Re: Initial Submission Review – Waterstone Site Plan No 4 – Site Plan and Plat
Application Number: **DA-1758-10**
Case Numbers: **2021-4016-00**

Initial Submission Review

Waterstone Filing No. 4
City of Aurora, Colorado
Drainage Plan
Historic Drainage

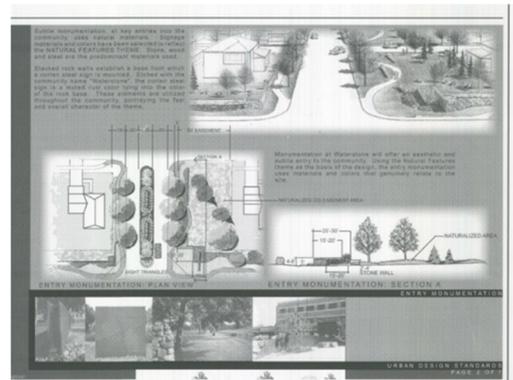
2G. Please update the data table to look similar to the graphic to the right. Please refer to the Site Plan Manual if you need additional detail.

Response: Data table updated to reflect the example.

c. Effect of Proposed Development

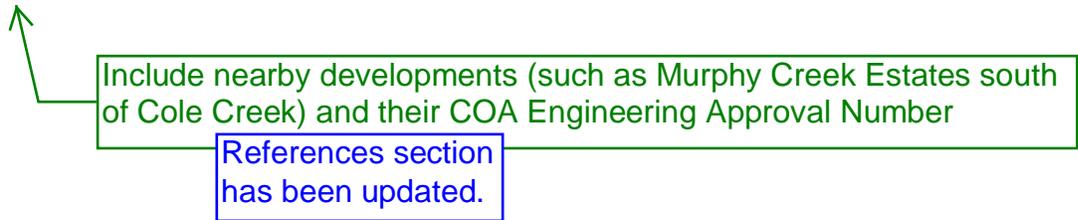
Compare existing and proposed flows reaching the property to the west (1950 Chambers Rd) and the Creek just downstream of Detention Pond A's outfall

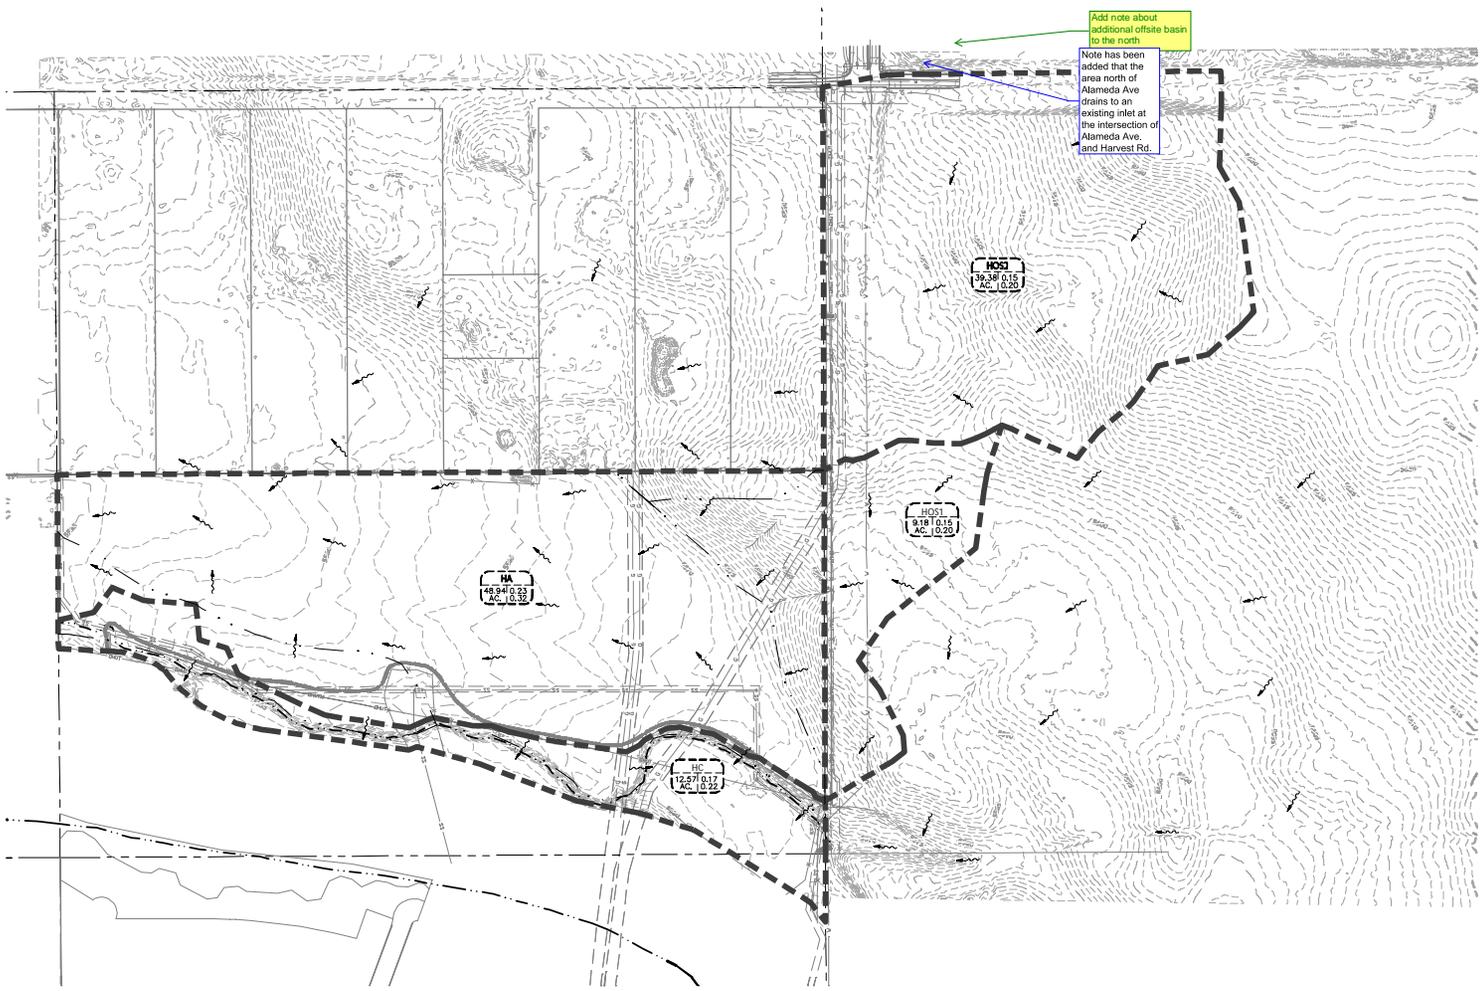
Add note about additional offsite basin to the north

Note has been added that the area north of Alameda Ave drains to an existing inlet at the intersection of Alameda Ave. and Harvest Rd.

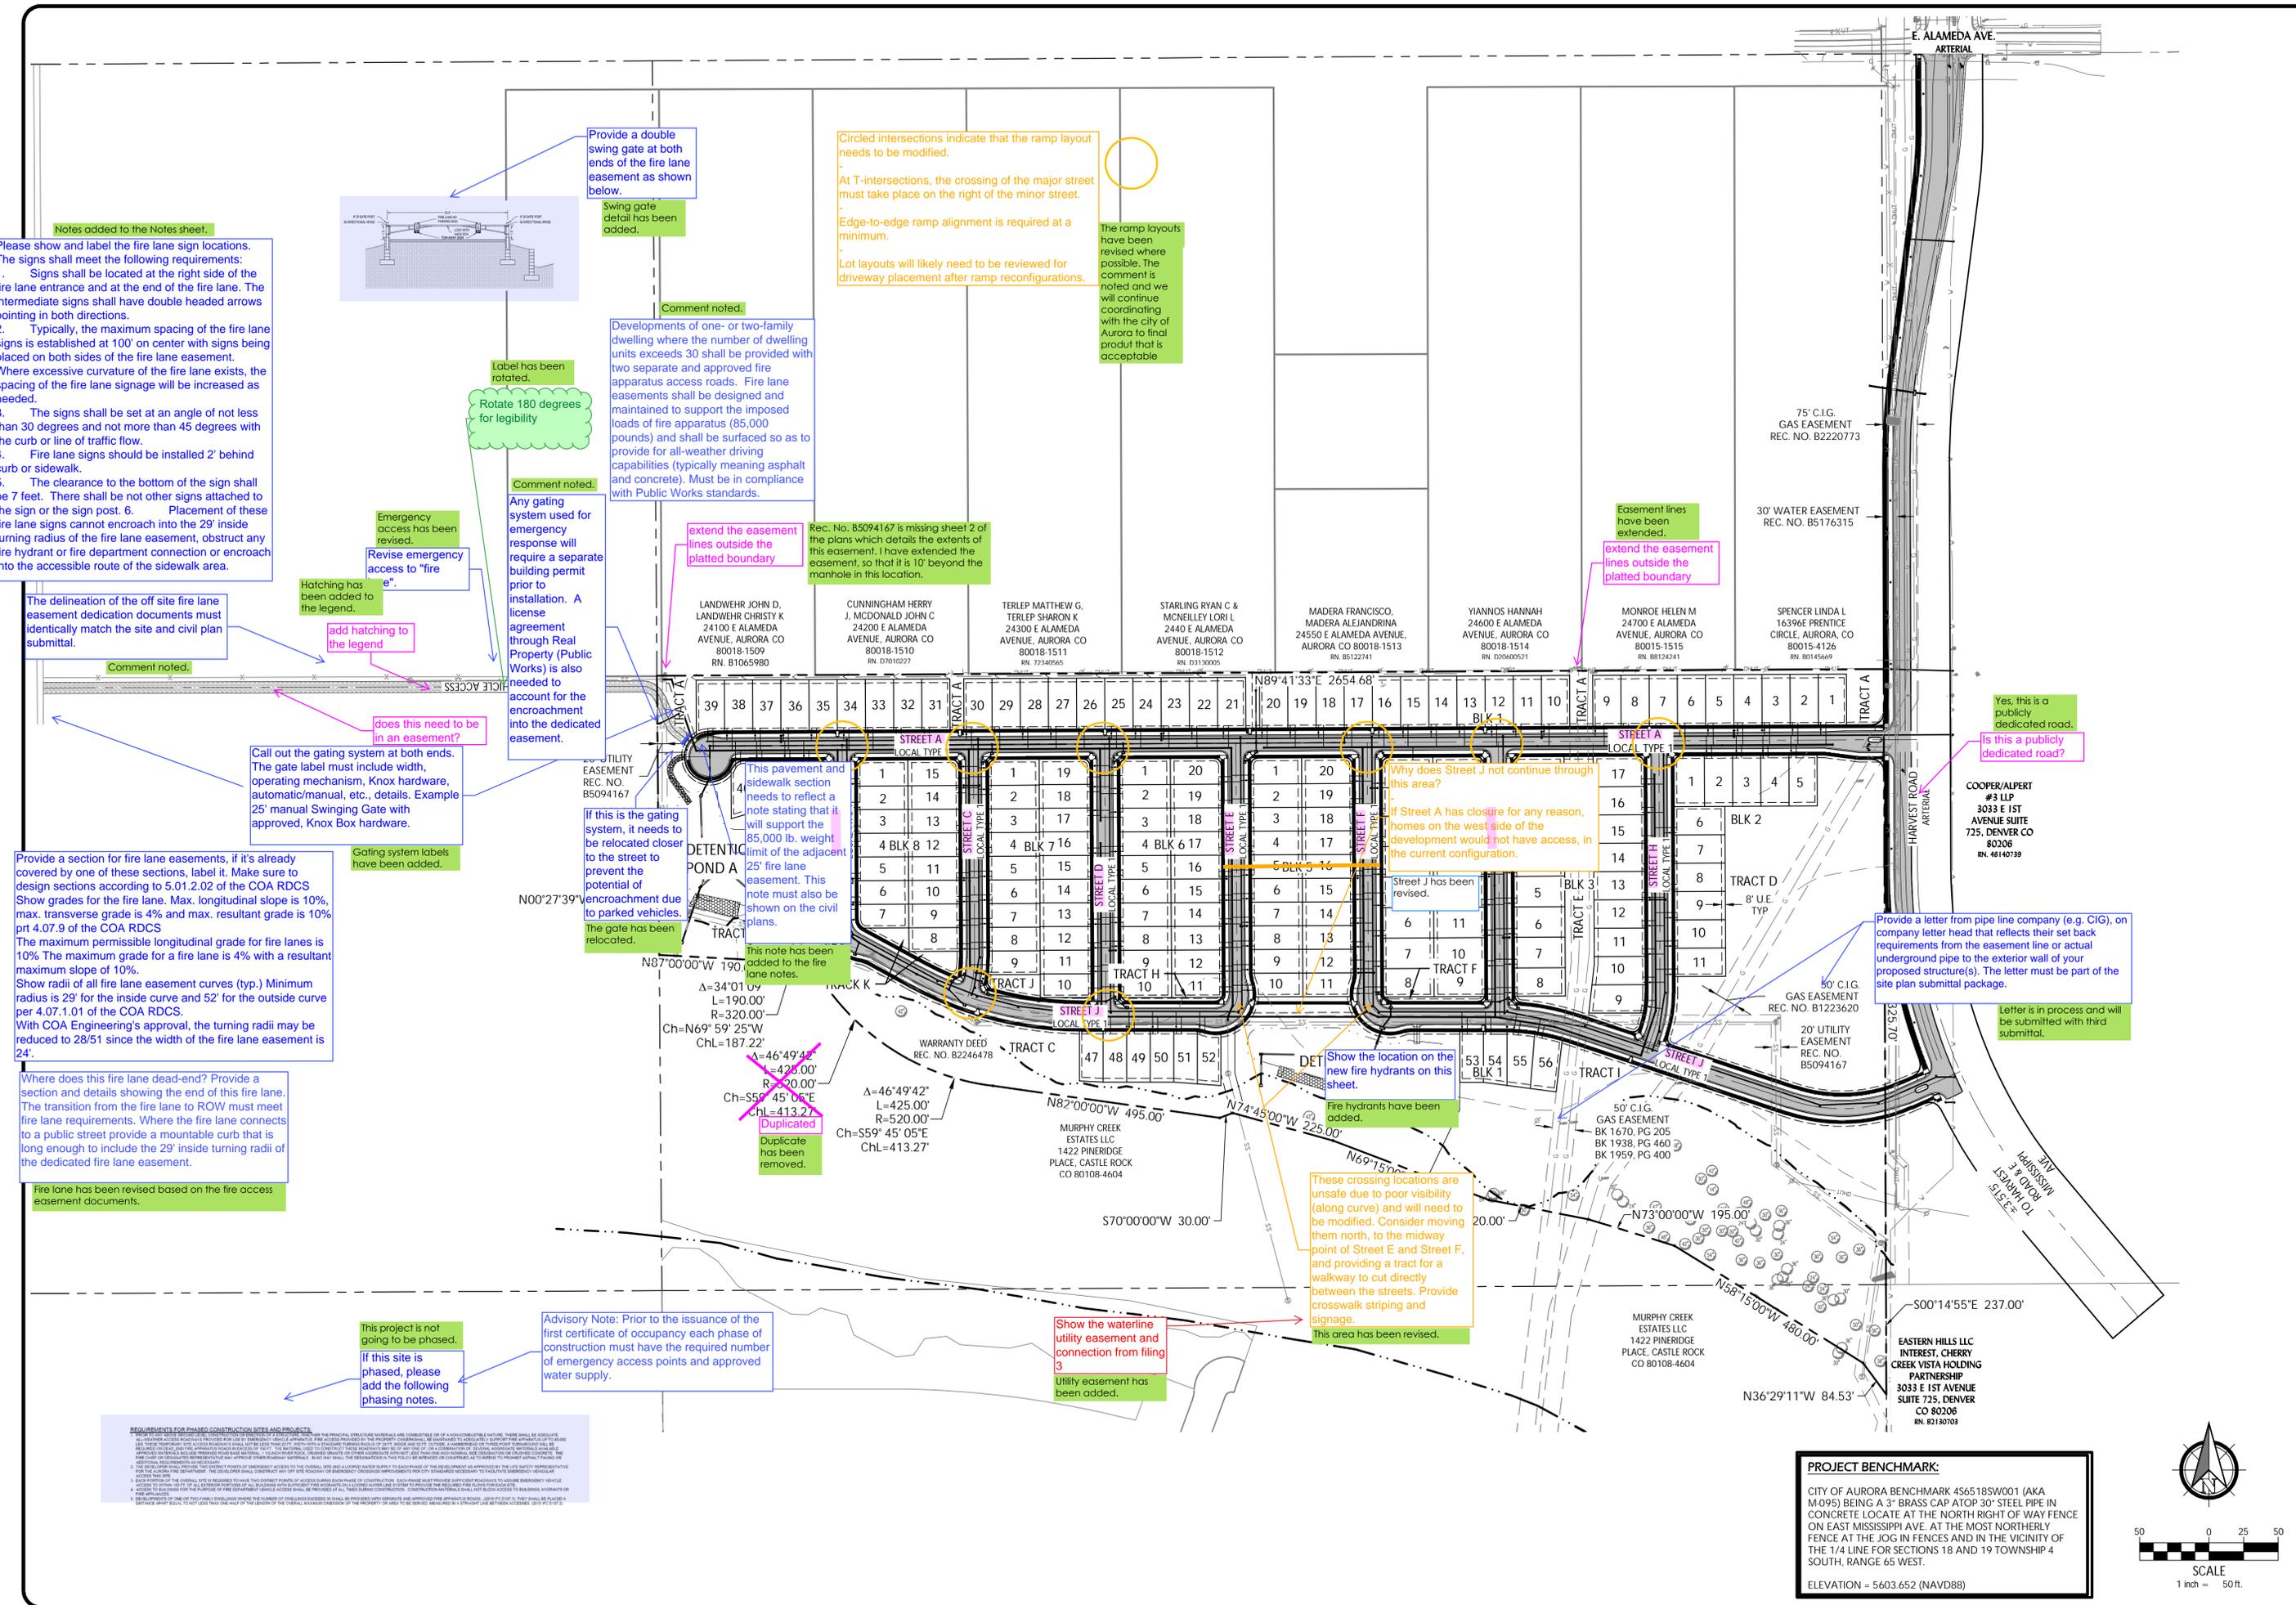
Notes added to the Notes sheet.
 Please show and label the fire lane sign locations. The signs shall meet the following requirements:
 1. Signs shall be located at the right side of the fire lane entrance and at the end of the fire lane. The intermediate signs shall have double headed arrows pointing in both directions.

2. Typically, the maximum spacing of the fire lane signs is established at 100' on center with signs being placed on both sides of the fire lane easement. Where excessive curvature of the fire lane exists, the spacing of the fire lane signage will be increased as needed.

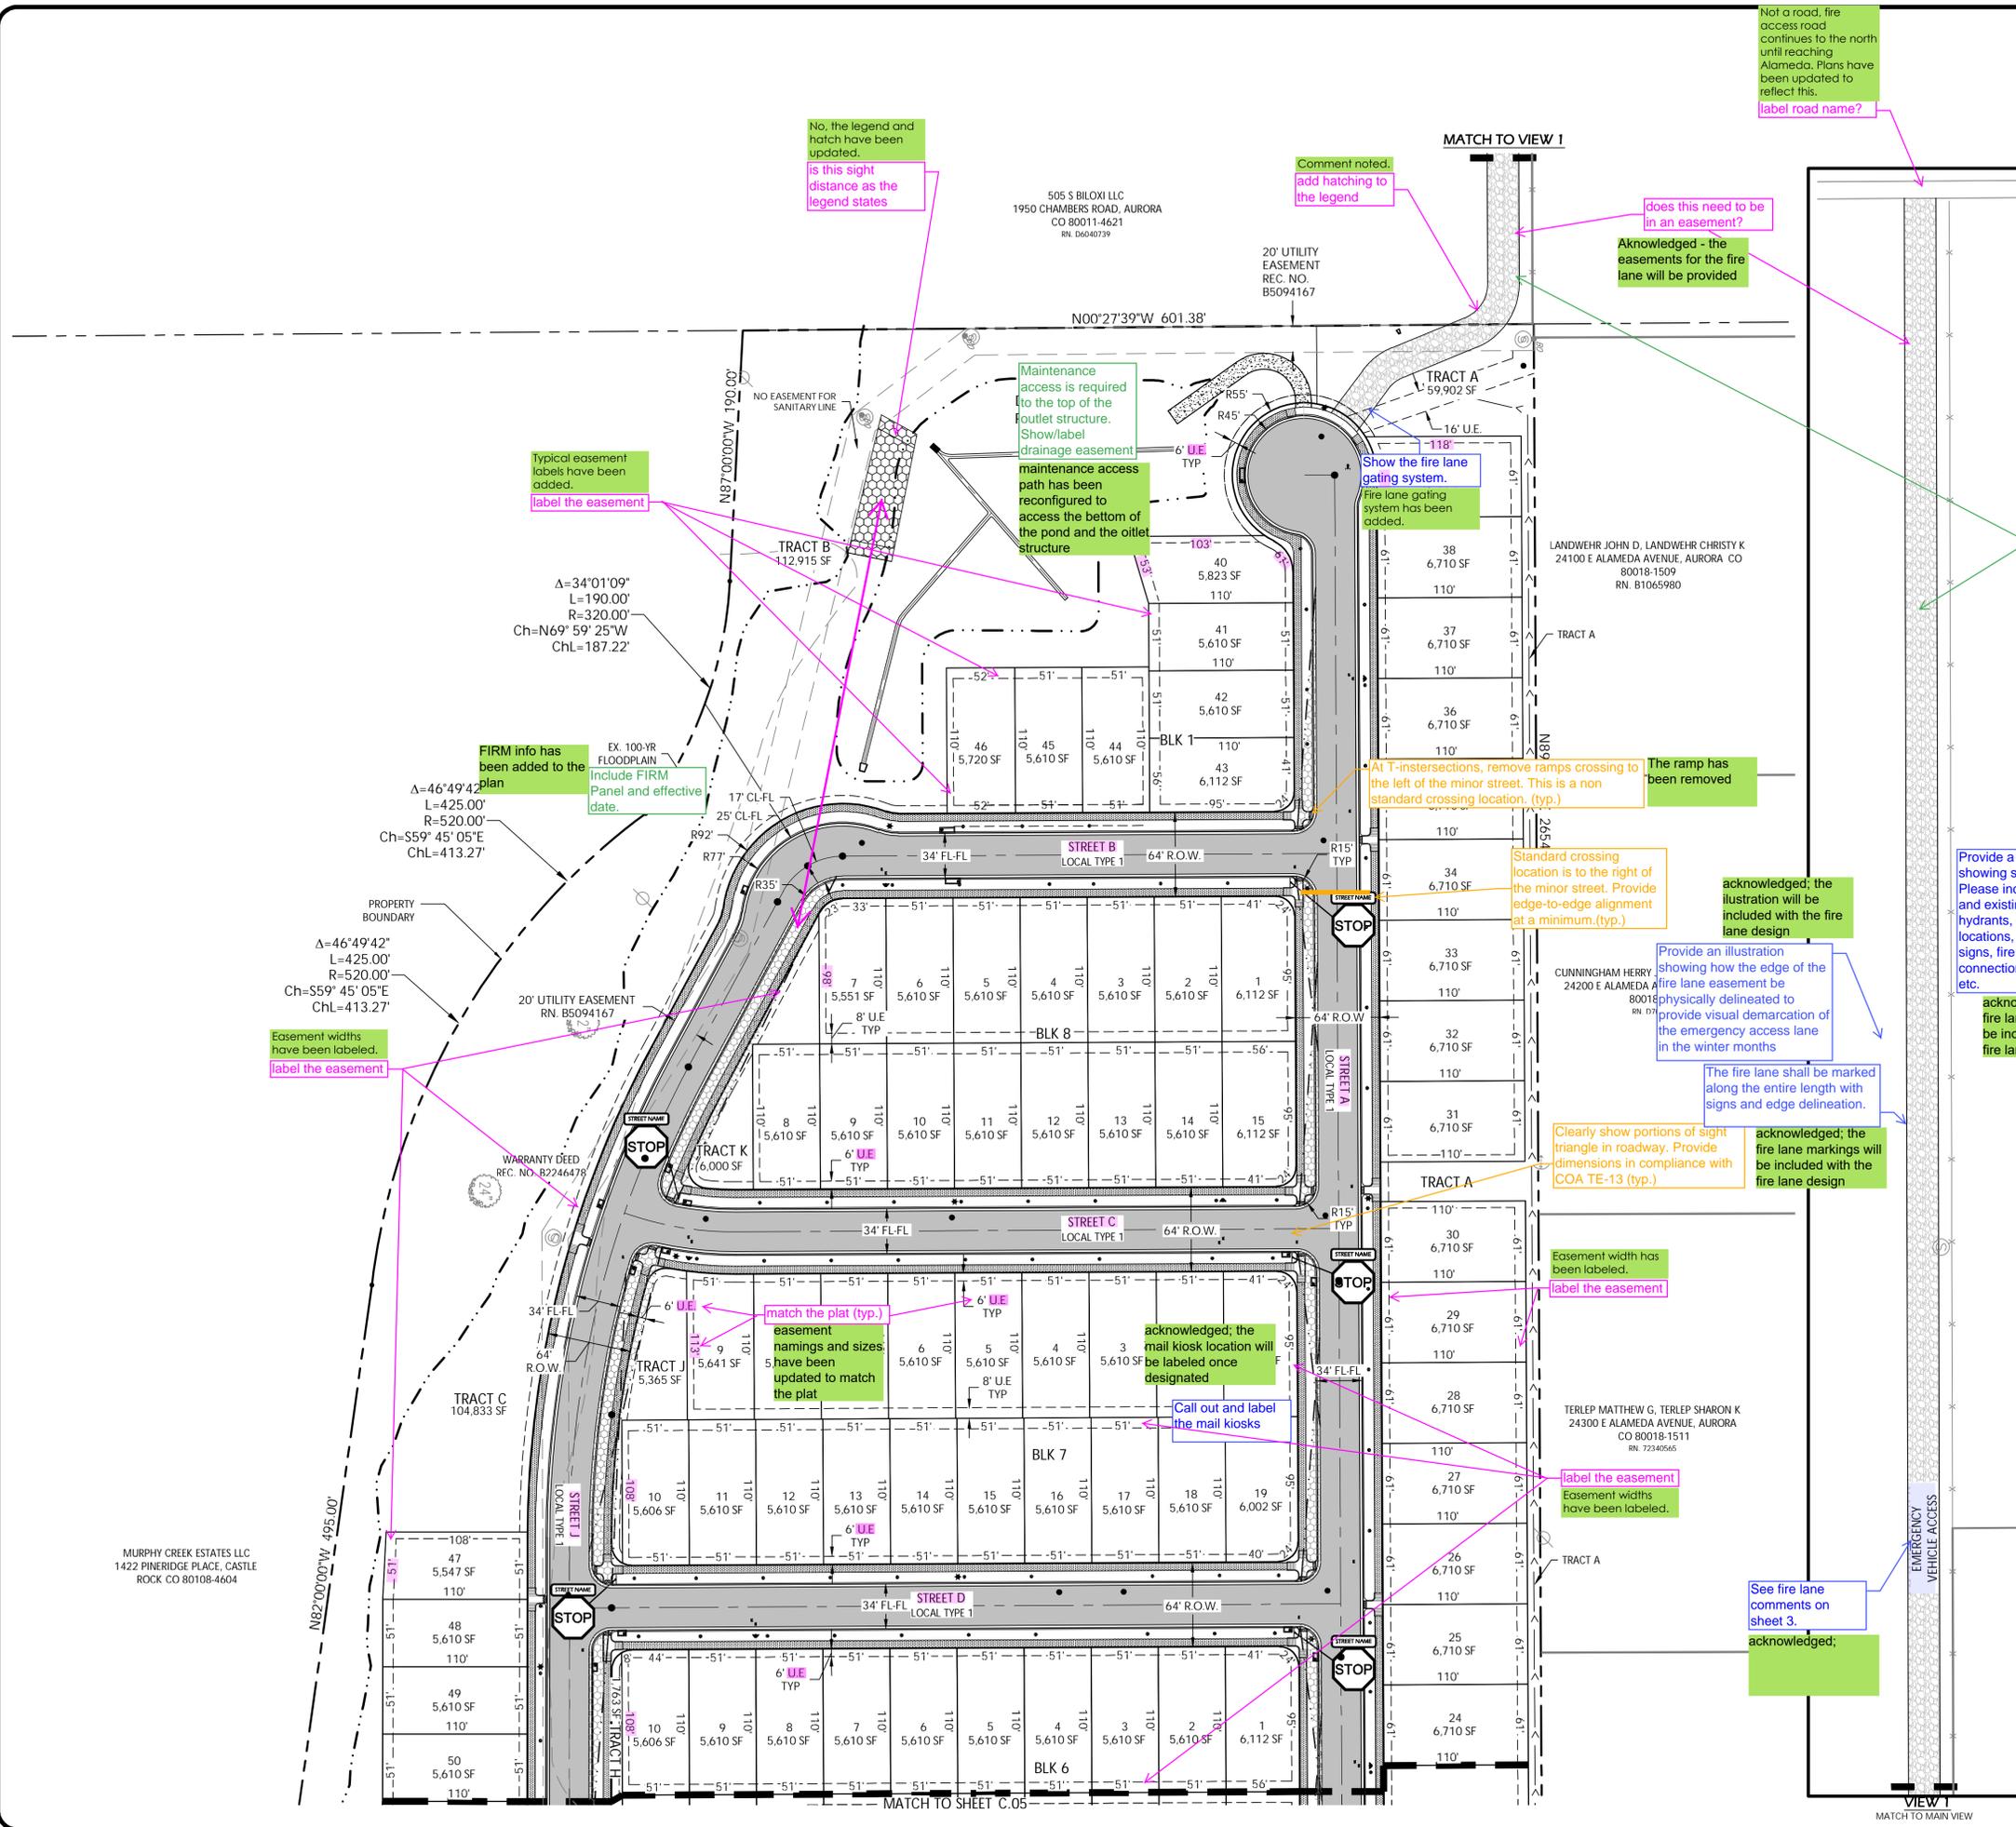
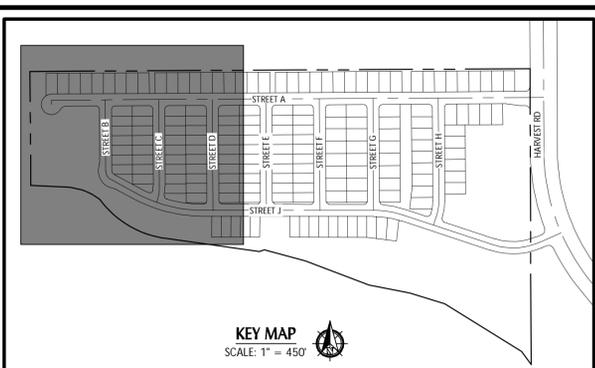
Why does Street J not continue through this area?
 If Street A has closure for any reason, homes on the west side of the development would not have access, in the current configuration.

Show the location on the new fire hydrants on this sheet.
 Fire hydrants have been added.

Street J has been revised.

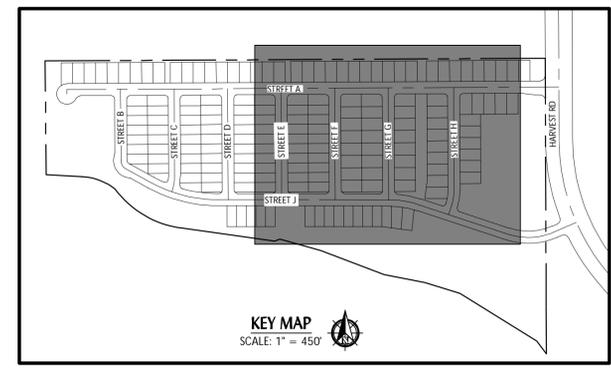
Provide a letter from pipe line company (e.g. CIG), on company letter head that reflects their set back requirements from the easement line or actual underground pipe to the exterior wall of your proposed structure(s). The letter must be part of the site plan submittal package. TYP of all gas easements.

Relocate this fire hydrant to this location. FH has been relocated.

the coordination with the pipe line is ongoing and letter is in the process of being obtained
